## MEMORANDUM TO FILE

*Date:* October 25, 2024  
*To:* File  
*From:* Jennifer McKellar  
*Re:* Potrero Yard Modernization Project (2500 Mariposa Street)  
(Modification of Potrero Yard Modernization Project – Increase in  
Bus and Bus Operator Count Numbers)  
Case No. 2019-021884ENV

Project Description Memo: Modification of Potrero Yard Modernization Project – Increase in Bus and Bus Operator Count Numbers

Date: October 25, 2024  
To: Jennifer McKellar San Francisco Planning Department  
From: Wade Wietgreffe, San Francisco Municipal Transportation Agency  
Through: Liz Nagle, San Francisco Municipal Transportation Agency  
Re: **Potrero Yard Modernization Project** (Modification of Potrero Yard Modernization Project – Increase in Bus and Bus Operator Count Numbers)  
Case Number: 2019-021884ENV

Figure 2a: EIR Project - Transit Level 2

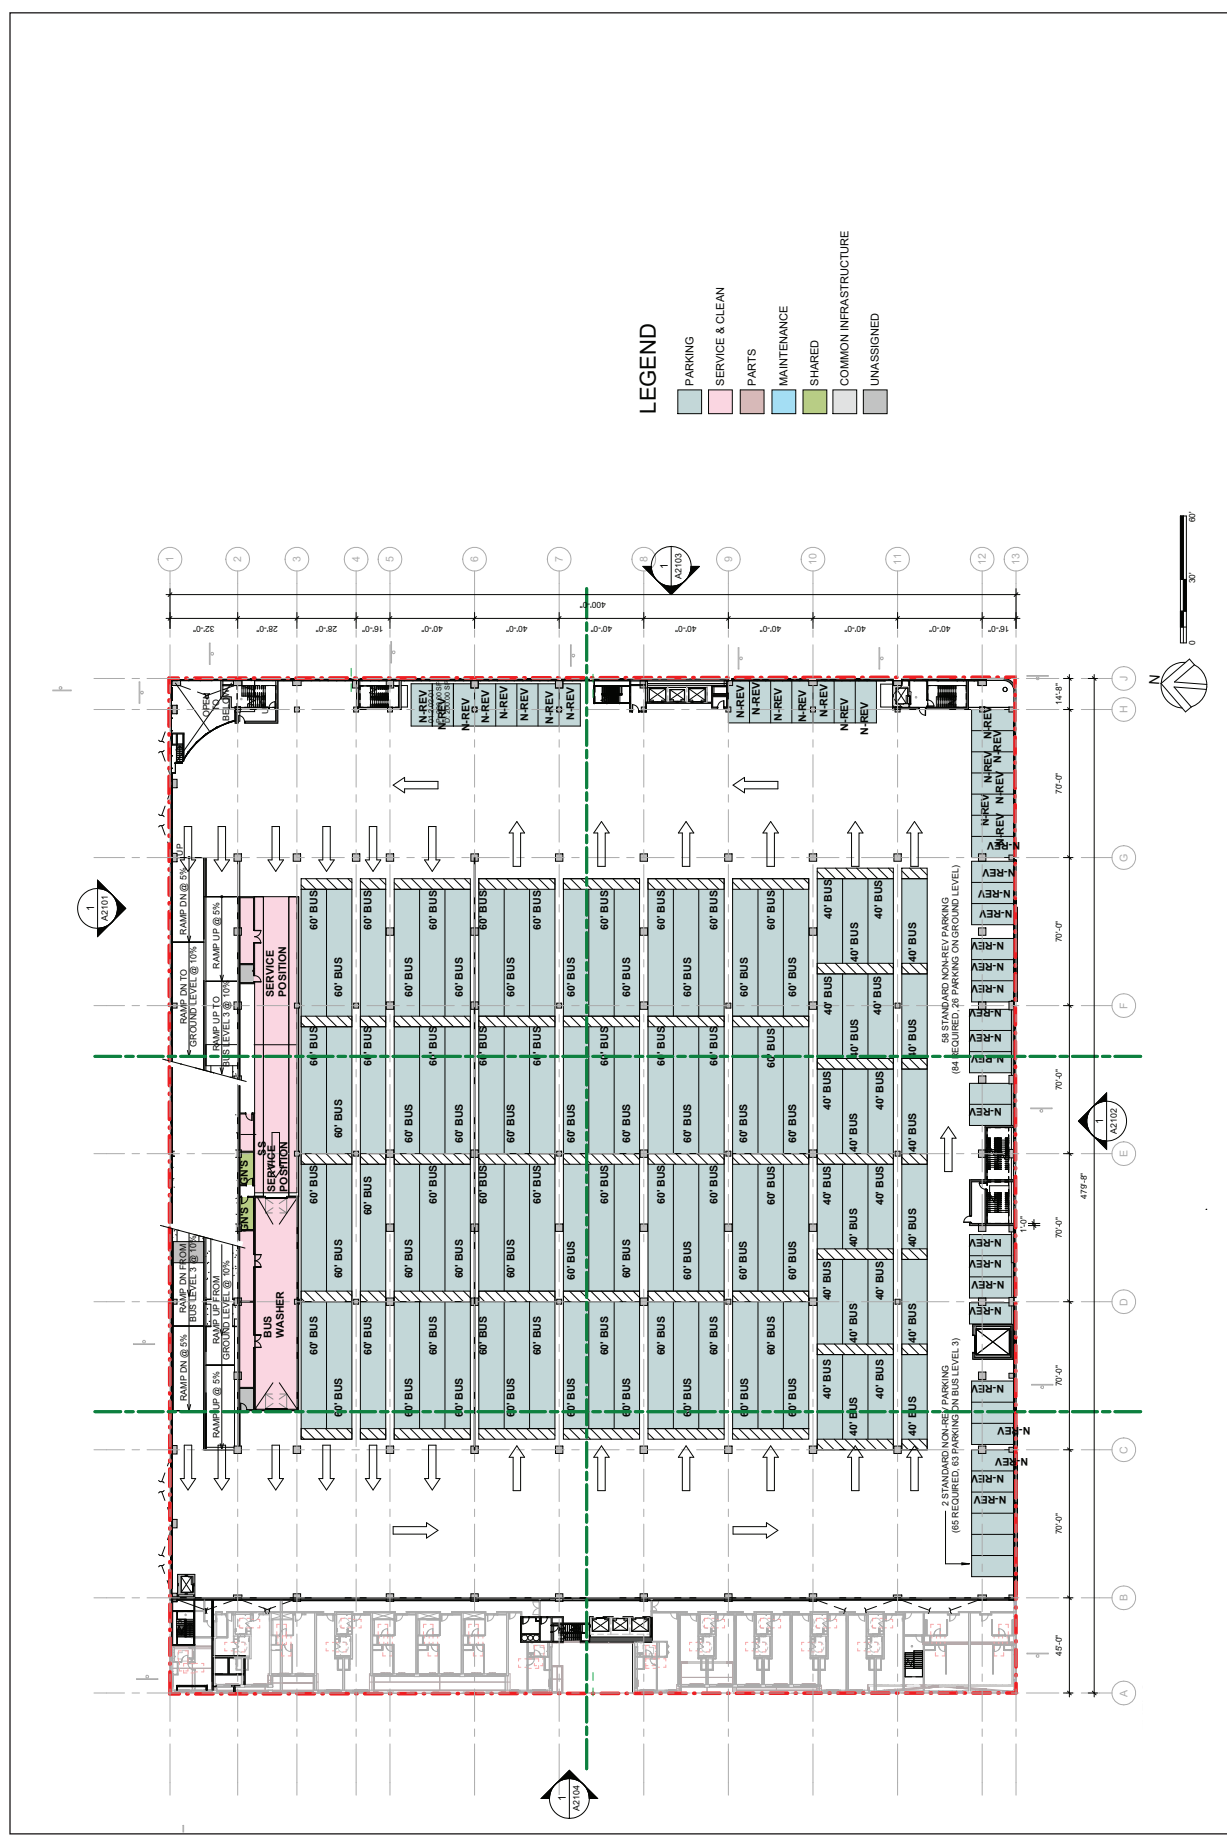
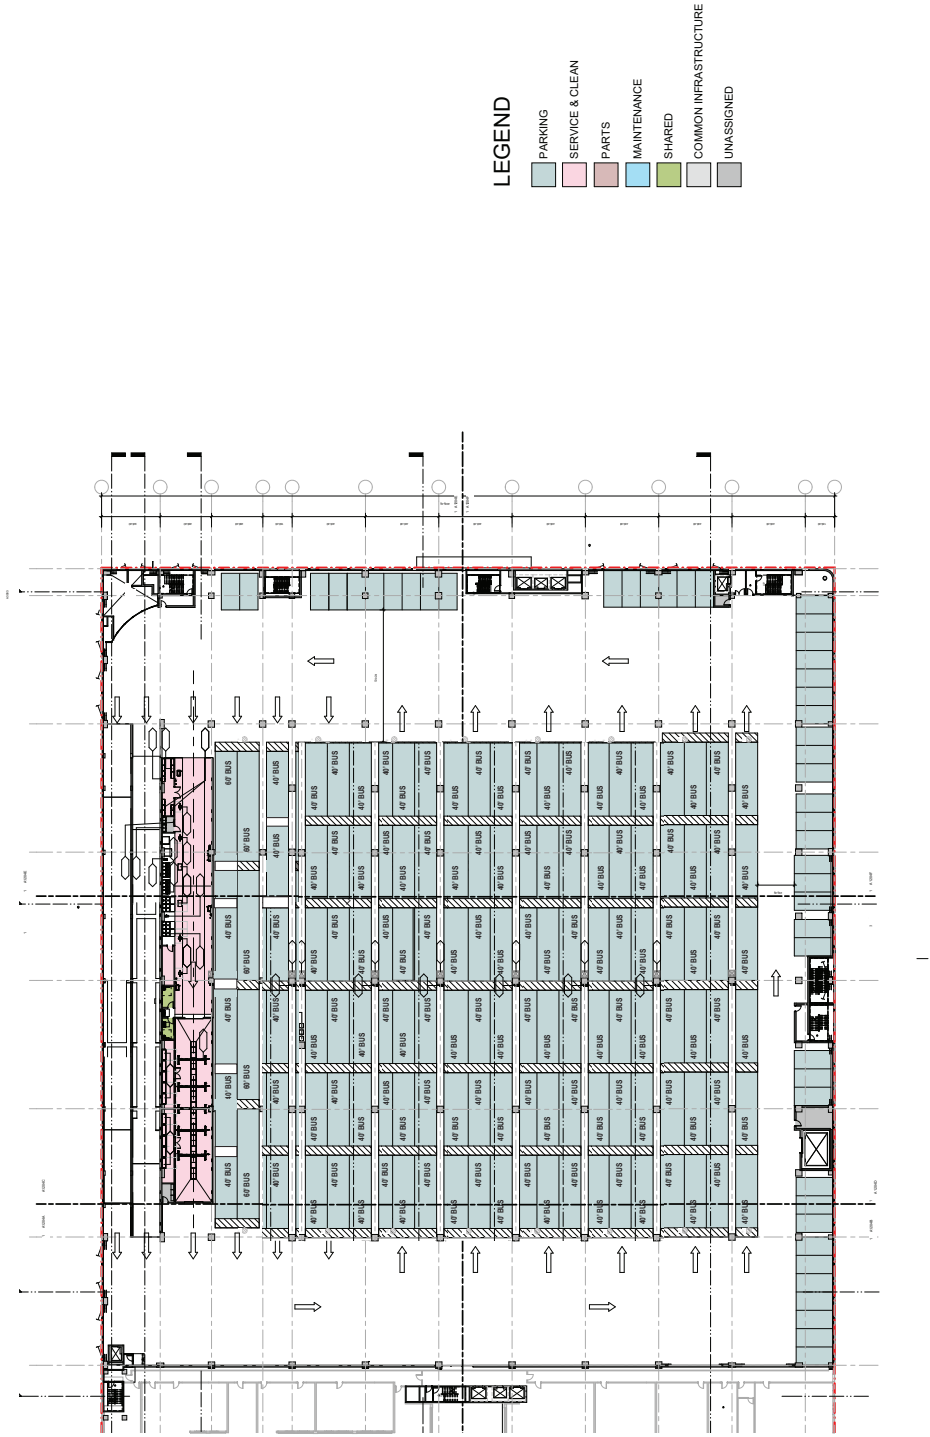
The modified project would alter the proposed striping on the second level of the replacement transit facility to accommodate the 33 additional buses. Modified striping would include converting 67 60-foot bus parking spaces in the EIR project to 100 40-foot bus parking spaces in the modified project. **See Figure 2a and Figure 2b in Attachment A.** It is anticipated that the increase in 33 buses under the modified project would also include an increase in SFMTA employees to operate the buses. It is estimated that the modified project would require 301 additional operators compared to the EIR project.<sup>2</sup> See Table 2 for details.
